HARDEN ADDITION

Re: S/D 96-53 HARDEN ADDITION (Final Plat)

CASE NUMBER: S/D 96-53 HARDEN ADDITION

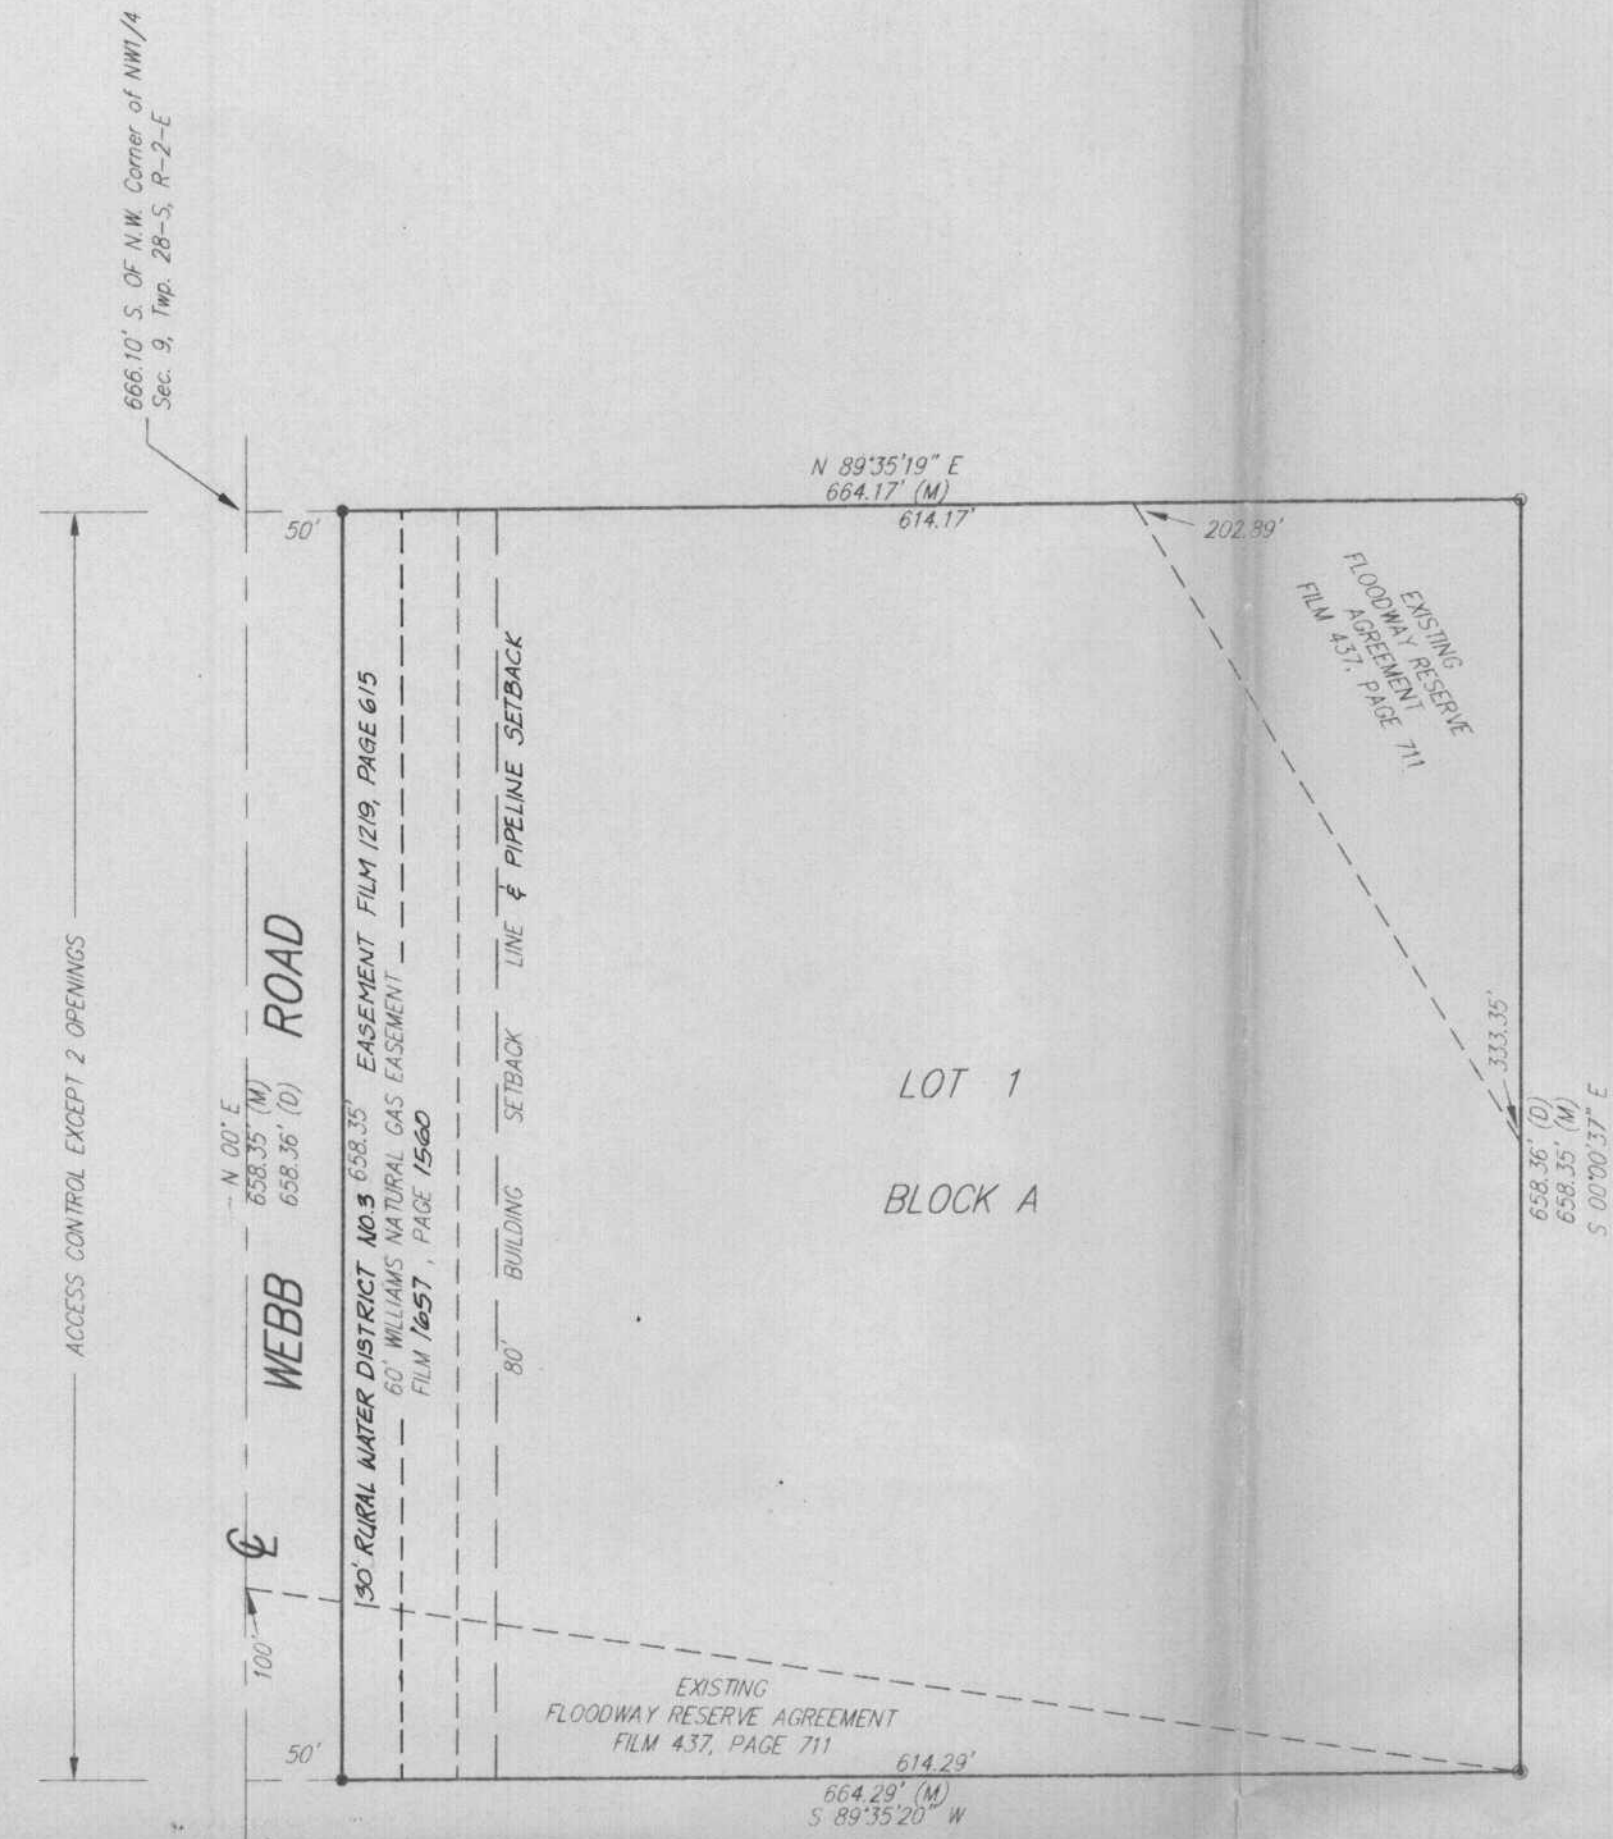
A. Since neither municipal water nor sanitary sewer is available to serve this property, the applicant shall contact the Environmental Health Division of the Health Department to find out what tests may be necessary and what standards are to be met for approval of on-site sewerage facilities and water wells. A memorandum shall be obtained specifying approval.
- B. The applicant shall guarantee any drainage improvements required by the platting of this property.
- See 1st meeting submitted by agent*

C. At this time, the plat is encumbered by a blanket pipeline easement. The 50-foot easement as now shown is the area to which it is expected that the easement will be confined to. Prior to this plat being scheduled for City Council review, this pipeline shall have been confined as is being noted. The final plat tracing shall, therefore, properly reflect the easement as confined. A copy of the recorded document creating this easement and therefore releasing the blanket easement shall be submitted to Planning. The final plat tracing shall also indicate the easement's recording information and the name of the involved pipeline company.

- D. Any relocation, lowering or encasement of the pipeline, made necessary by this development, will not be at the expense of the County.
- E. The platting binder notes that a rural water district easement is located along the west line of this site. It is not clear, however, if this easement is located on the plat itself or is in street right-of-way. If this easement is on the site itself, in whole or part, the final plat

tracing shall depict the easement and properly label the easement and show the recording information.

- ~~F.~~ On the final plat tracing, the street adjacent to this site shall indicate only the name of Webb Road.
- ~~G.~~ In order to retain a platted setback to Webb Road in the event the pipeline and easement were ever removed, the indicated 80-foot building setback shall be labeled as a "platted and pipeline" building setback.
- ~~H.~~ *OK current to Res. 2111111111*
Since a floodway apparently impacts this site, the plat's text shall reference the standard floodway language.
- ~~I.~~ Since a minimum building pad elevation (1362 MSL) is required, both the plat's text and the face of the plat shall note such an elevation.

Also, both on-site and off-site benchmarks shall be provided.

- ~~J.~~ On the final plat tracing, Deputy shall be deleted from the City Clerk's signature line.
- ~~K.~~ The applicant shall install or guarantee the installation of all utilities and facilities which are applicable and described in Article 8 of the MAPC Subdivision Regulations. (Water service and fire hydrants required by Article 8 for fire protection shall be as per the direction and approval of the Chief of the Fire Department.)

- ~~Q.~~ As requested by the utilities, the final plat tracing shall indicate a 10-foot utility easement

along the north line of the plat.
